**FINAL TECHNICAL DRAINAGE STUDY
FOR
WASHINGTON LAS VEGAS WASH
PARK**

865-012

July 2017

Response to Comments/Comment Letter

OWNER: CITY OF LAS VEGAS
DEPARTMENT OF PUBLIC WORKS
400 EAST STEWART AVENUE
LAS VEGAS, NEVADA 89101
PHONE: (702) 229-6335
FAX: (702) 584-8846
TDD: (702) 584-3108
DESIGNER: FUG
FILE: AS SHOWN
DATE: 07/26/17
SCALE: AS SHOWN
SHEET NO: 1553811DC
CITY ENGINEER: 65015
CIVIL NO: 53811
SHEET NO: C3.01

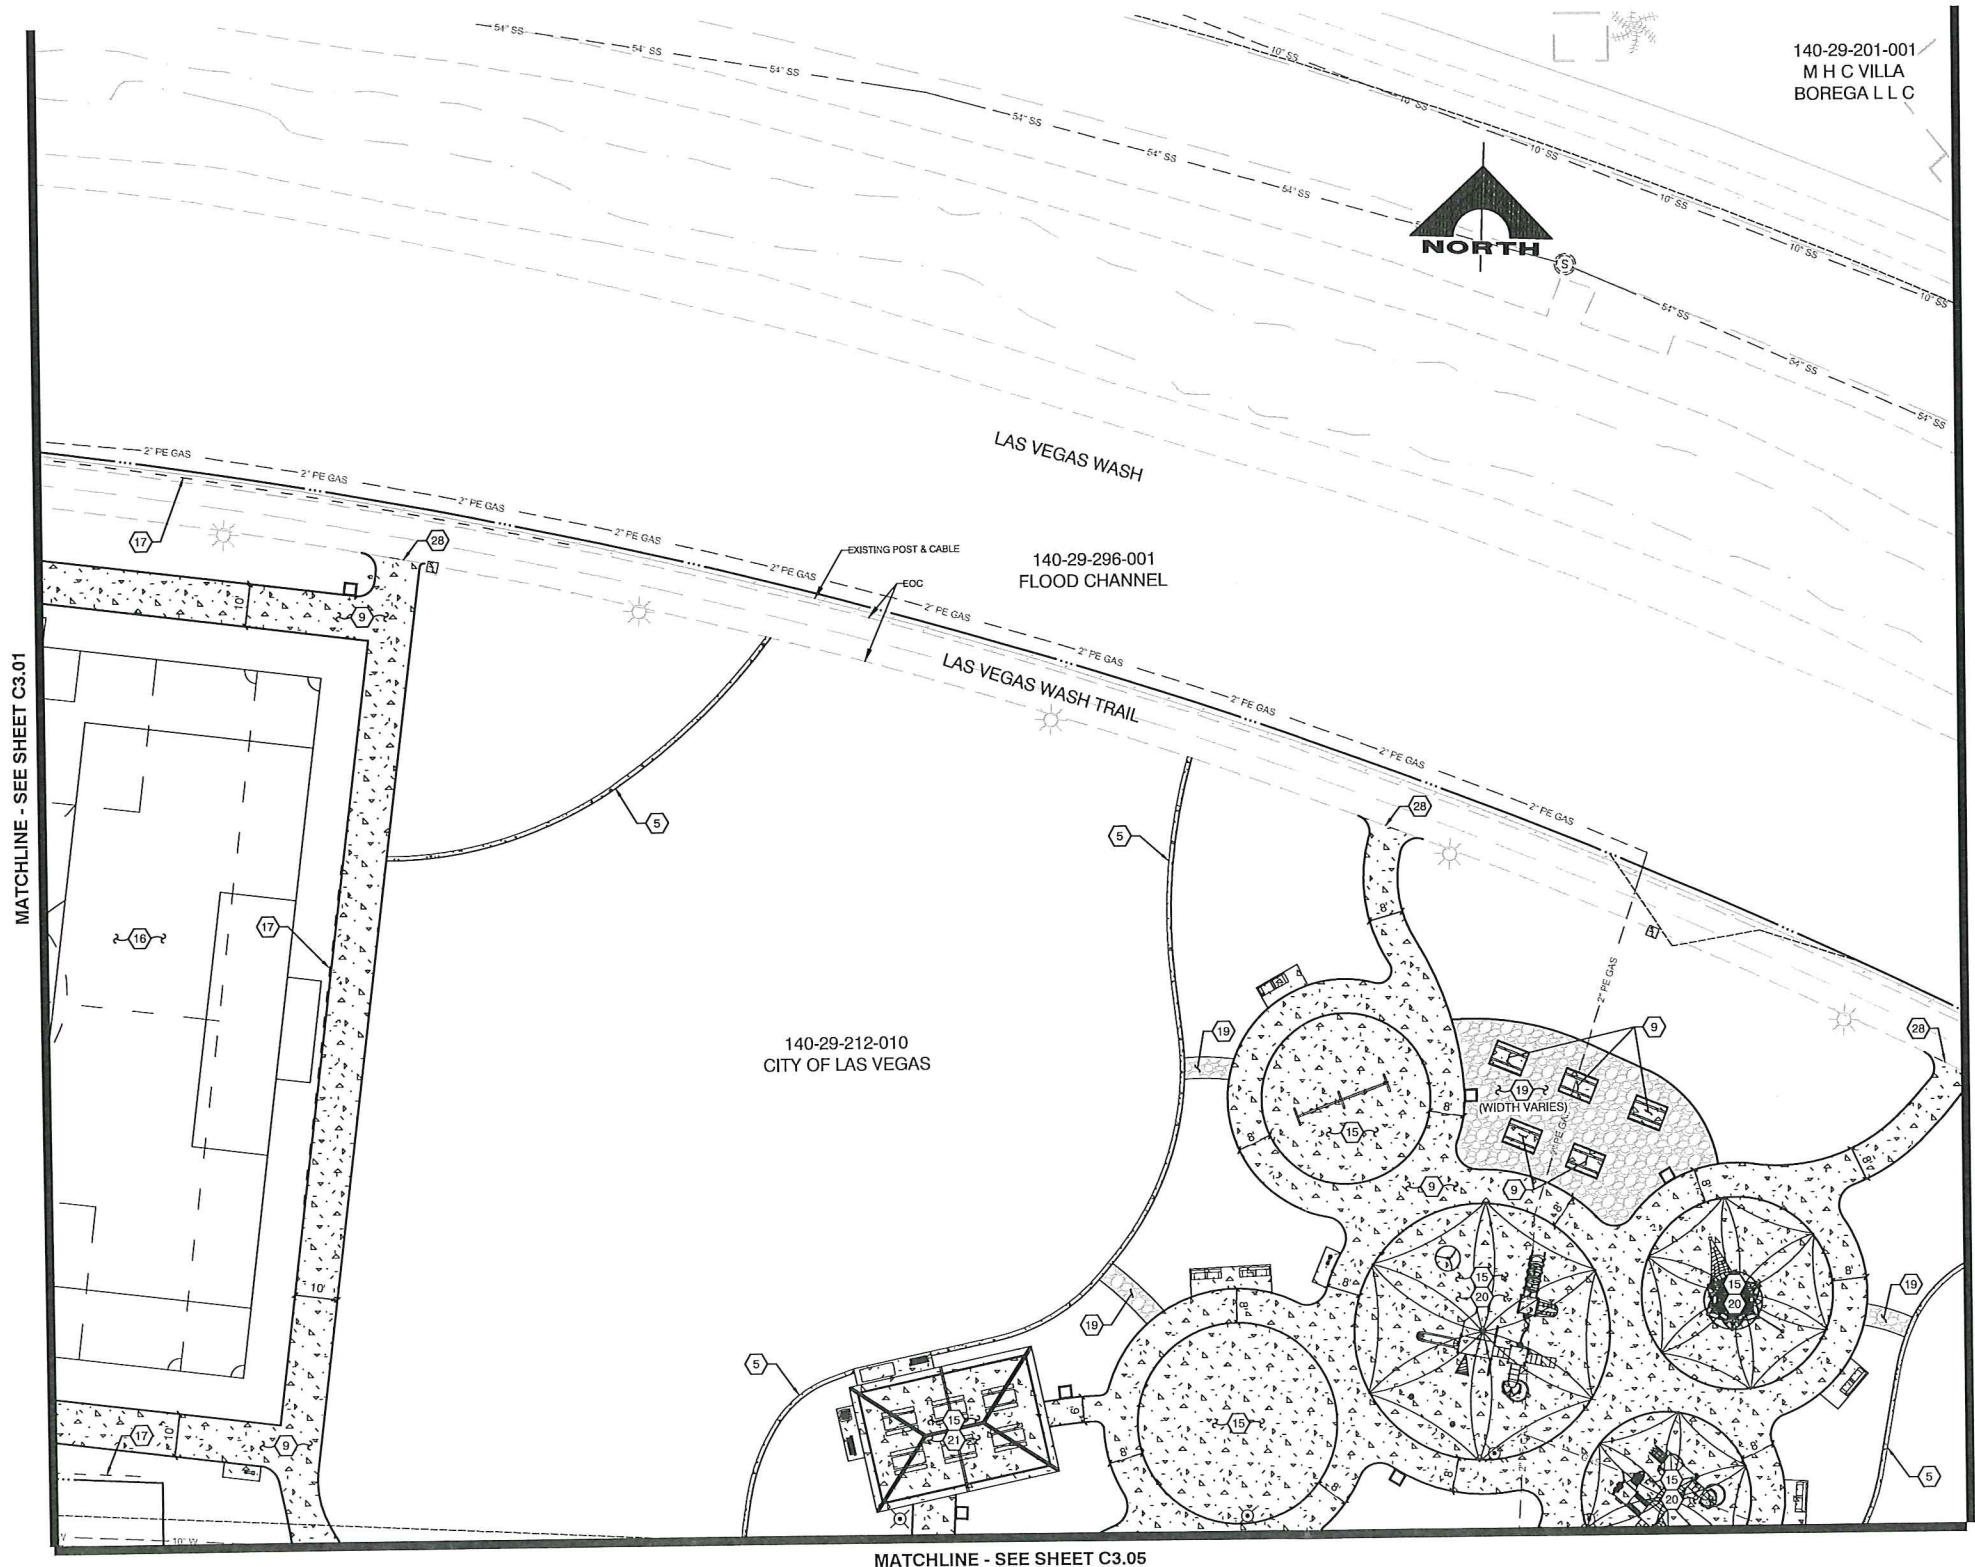
Comment: "10. Sheet C3.01: Provide reference sections for matching into existing improvements."

Response: Notes have been added to the plans. See sheet section 5 on sheet C3.07.

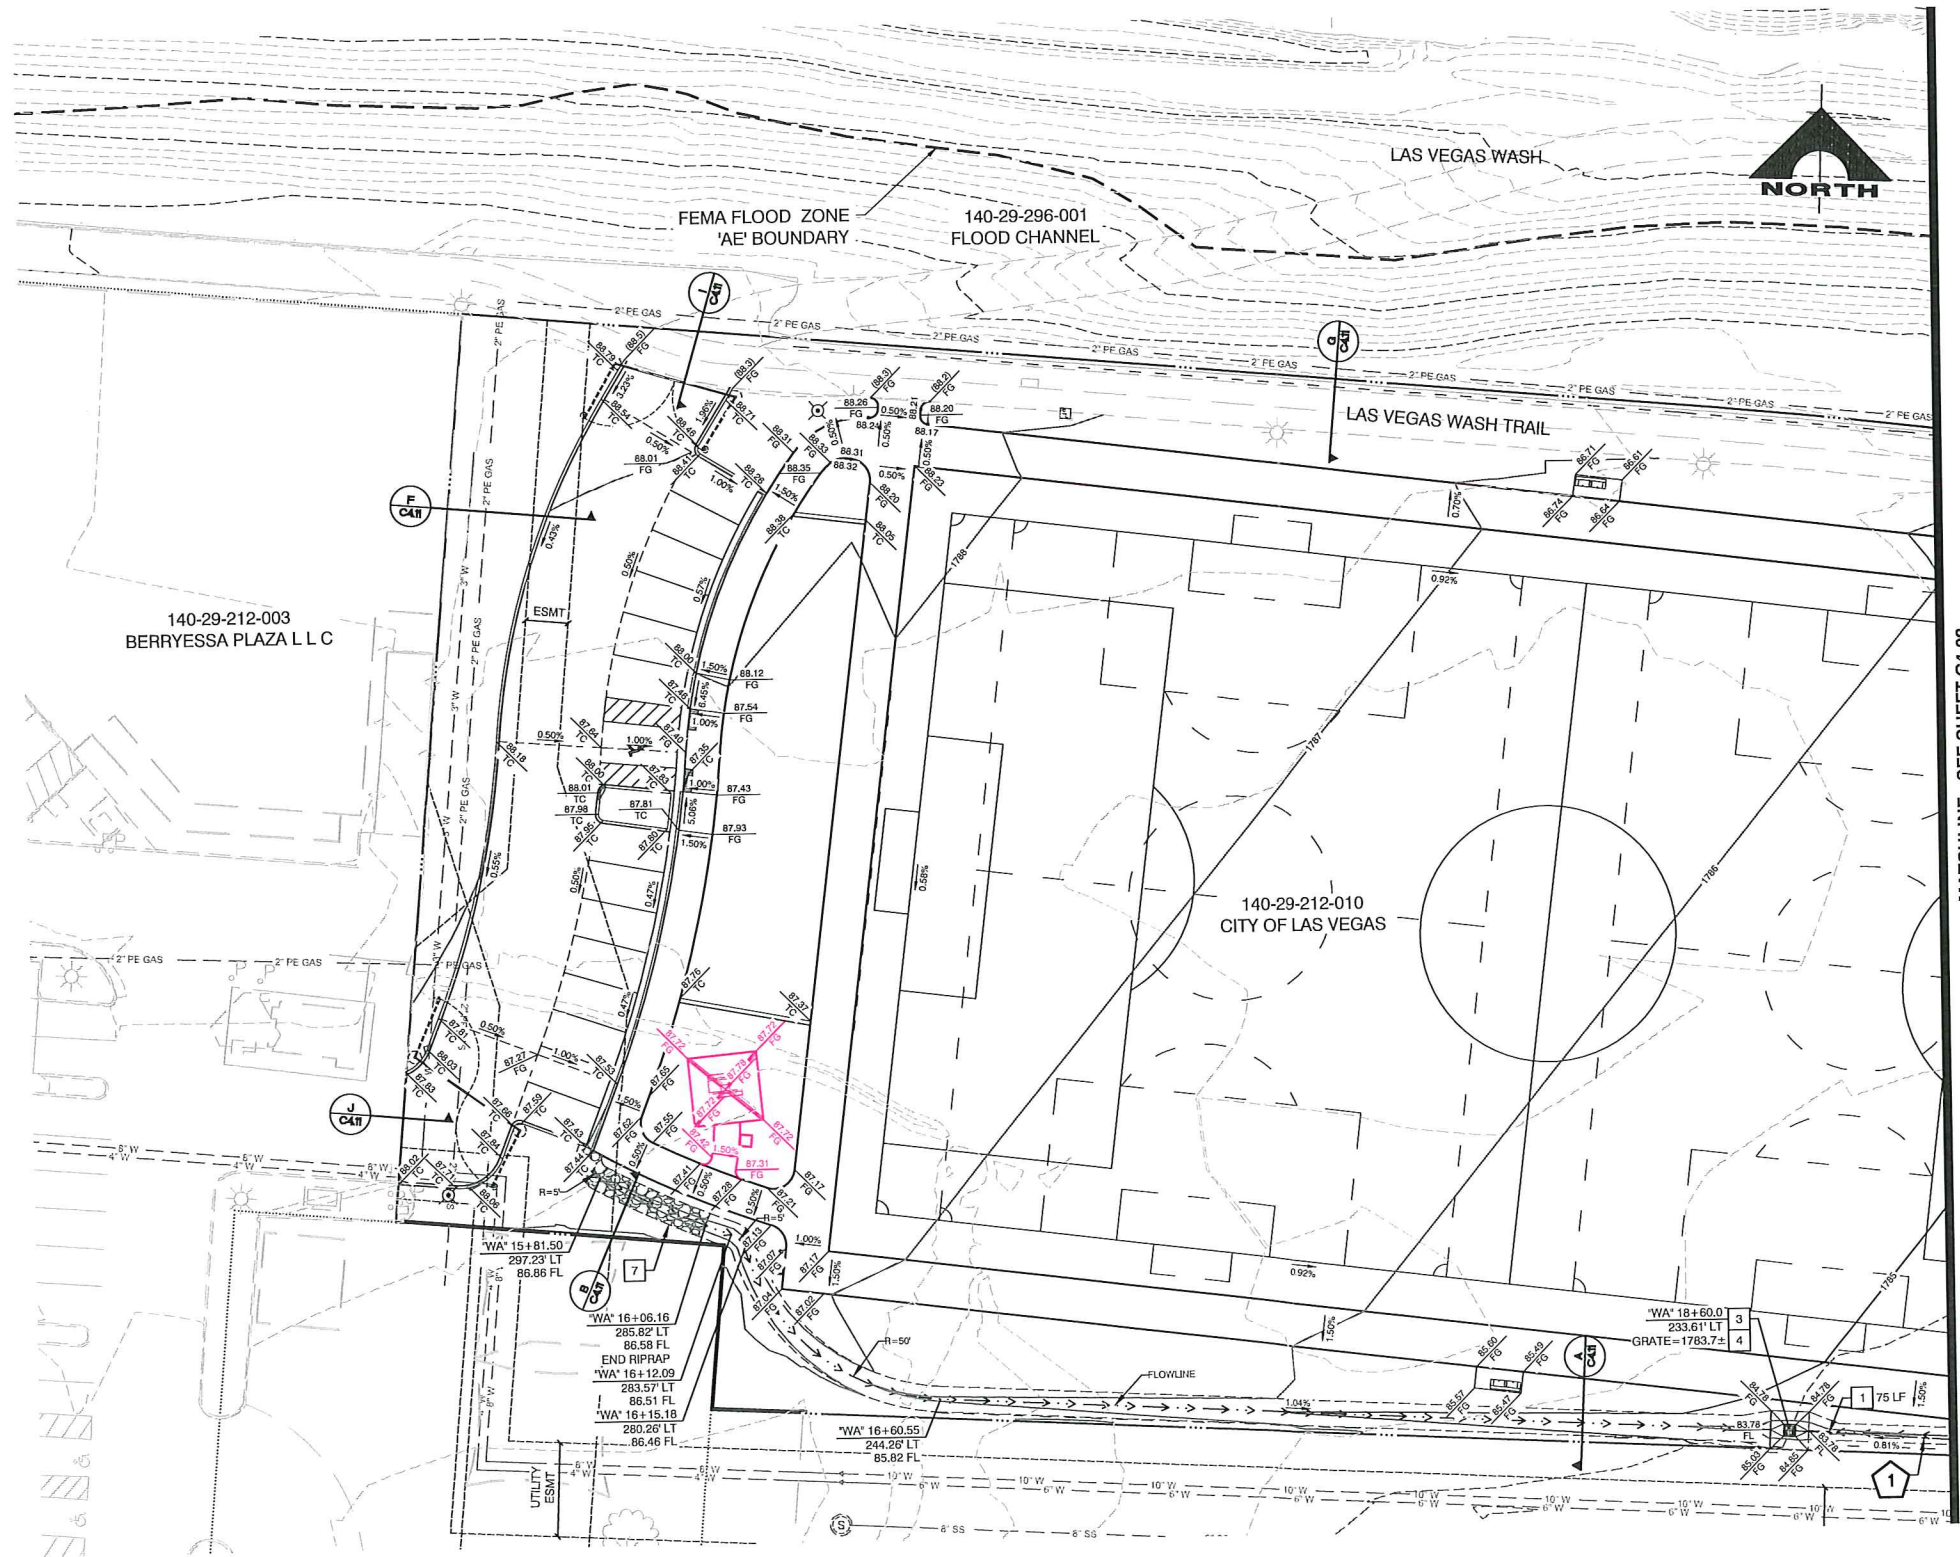
Comment: "2. The graded swale on Sheet C4.01 does not match the Landscape Plans that shows a meandering river rock swale. Review and revise accordingly"

Response: The Landscape Plans and drainage swale on Sheet C4.01 now coincide.

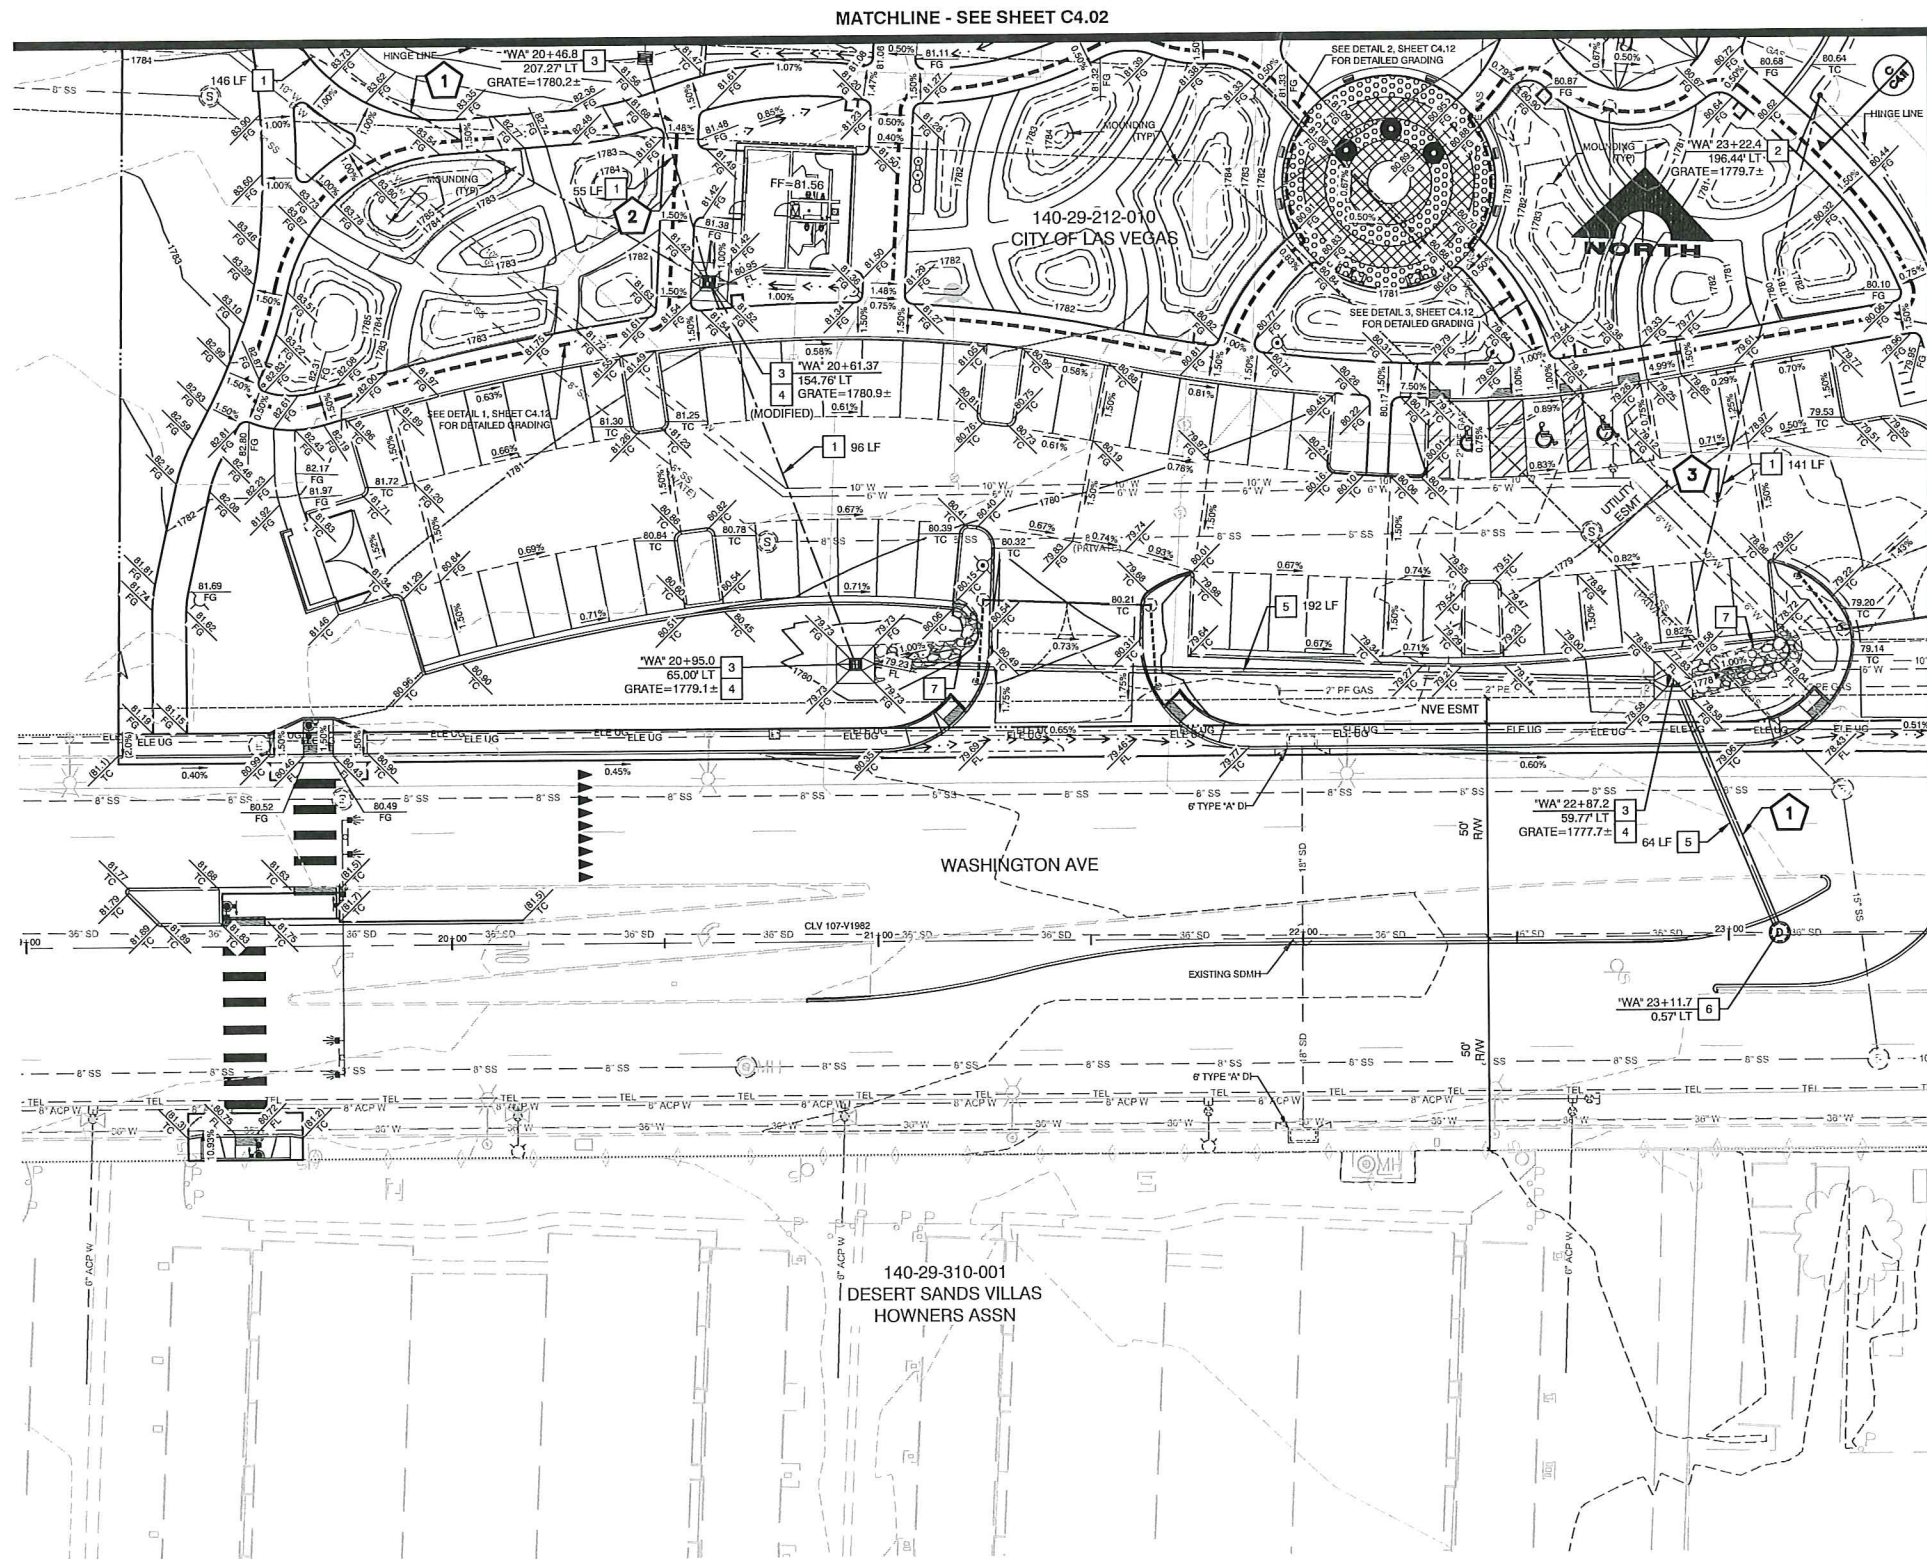
Comment: "12. Sheet C4.04: Verify inlet box size will accommodate the three storm drain lines. Revise the inlet northwest of the restroom/storage building to an NDOT Type 2 inlet with concrete apron. Provide Finish Floor elevation for restroom/storage building."

Response: Inlet box size can accommodate the three storm drain lines as mentioned in response to comment #1. Inlet located northwest of the restroom/storage building will not be revised to include a concrete line apron due to the grass-lined contributing area. Additional concrete in the play area may be considered a trip hazard. However, the NDOT Type 2 inlet next to restroom/storage building which is in desert landscaping will have a concrete apron. Finished floor elevations provided on restroom/storage building. The restroom meets CLV finished floor criteria, which is above twice the depth of flow as shown in Cross Section 6 which is a normal depth calculation for the swale adjacent to the restroom is included in Appendix B.

SECTION K
NOT TO SCALE
C4.11

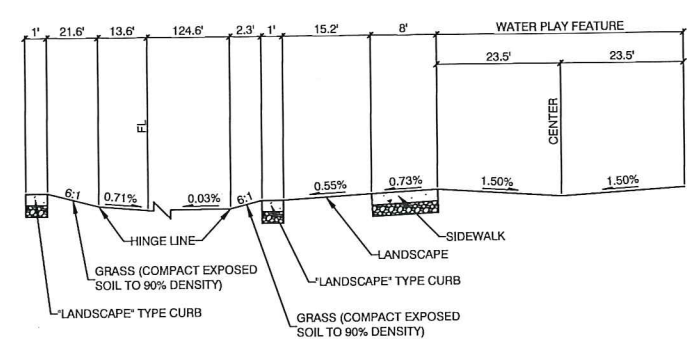
Comment: "11. Sheet C4.02: Provide a cross section near the water feature to show that the water feature is sufficiently elevated to prevent offsite flows from impacting water feature drain."

Response: Section K on Sheet C4.02 and C4.10 is provided. The hydraulic calculation, Section 8 on Figure 6, shows that the water feature is sufficiently elevated to prevent offsite flows from impacting the water feature.
